MIDLAND ENERGY CENTER
MIDLAND DOCKET NOS 50-329, 50-330
NRC REQUEST FOR ADDITIONAL INFORMATION ON
VOLUME IX OF THE SEISMIC MARGIN REVIEW REPORT
FILE: B3.7.1 SERIAL: 29822

ATTACHMENT: RESPONSE TO NRC QUESTIONS ON SEISMIC MARGIN REVIEW VOLUME IX

RESPONSE TO NRC QUESTIONS ON SEISMIC MARGIN REVIEW
MIDLAND ENERGY CENTER PROJECT
VOLUME IX
BALANCE OF PLANT CLASS 1, 2, AND 3 PIPING
PIPE SUPPORTS AND VALVES

FIGURE 4-1. PVRC proposed damping vs RG 1.61 damping.

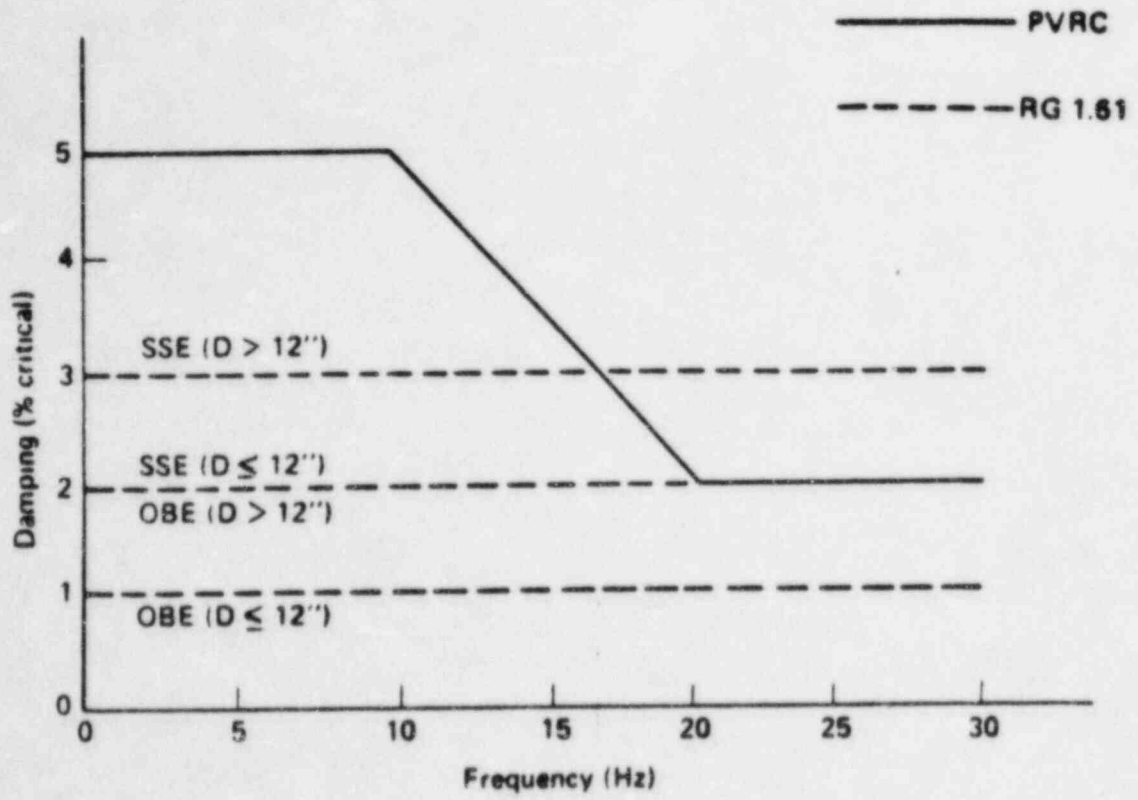
Question 4 Explain your use of 3% (SSE) damping for the 12" nominal line.
(Pgs IX-6-6, This is not in agreement with Regulatory Guide 1.61 October
IX-6-32) 1976. The Regulatory Guide states that 2% (SSE) damping
should be used for lines equal to or less than 12."

The damping used is consistent with the criteria and methodology initially proposed to the staff, Reference 1, and included in the Volume I, "Methodology and Criteria" report. Higher than Regulatory Guide 1.61 damping was proposed on the basis that experimental data supported increased damping for piping. After an extensive review of the existing damping data, the pressure vessel research committee (PVRC) has recently recommended damping substantially in excess of the Regulatory Guide 1.61 damping (and the 3% used in the Seismic Margin Review Report) with no differentiation in pipe size, see Figure 4-1 for comparison of Regulatory Guide and PVRC damping. The recent PVRC recommendation does result in lower than Regulatory Guide 1.61 damping for large diameter pipes (greater than 12 inches) at frequencies above about 17 Hz. Fundamental frequencies for the two systems in question are 10 Hz and below. In the first model cited, there are six modes below 17 Hz and in the second model there are 8 modes below 17 Hz. Above 17 Hz there is not a very significant difference in the SME spectra between 2% and 3% damping.
